**MINOR VARIANCE APPLICATION  
COMMENTS TO THE COMMITTEE OF ADJUSTMENT  
PANEL 1**

Site Address: 6 Oak Street  
Legal Description: Part of Lots 1, 2 and 3 on Registered Plan 82974  
File No.: D07-02-24/A-00031  
Report Date: March 14, 2024  
Hearing Date: March 20, 2024  
Planner: Margot Linker  
Official Plan Designation: Downtown Core, Neighbourhood, Evolving Overlay  
Zoning: R4UB (Residential Fourth Density, Subzone UB)

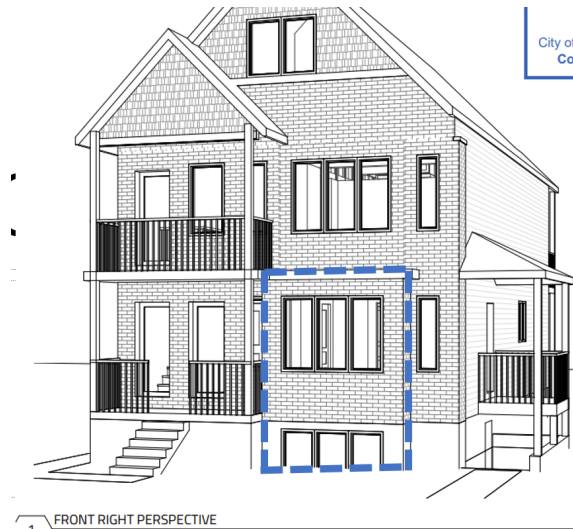
Staff have no concerns with the front yard setback as proposed on the plans stamped 2024-02-23. There is a contiguous front yard setback for every dwelling on Oak Street and many have balconies and porches projecting into the front yard. There are also

many dwellings that have bay windows and other large architectural projections. It is staff's understanding that the relief required is only for the area outlined in blue on the image below, and that the rest of the wall is set back 4.45 metres. While this wall does not qualify as a projection, like a bay window, staff don't believe that it breaks the established massing pattern on this street.
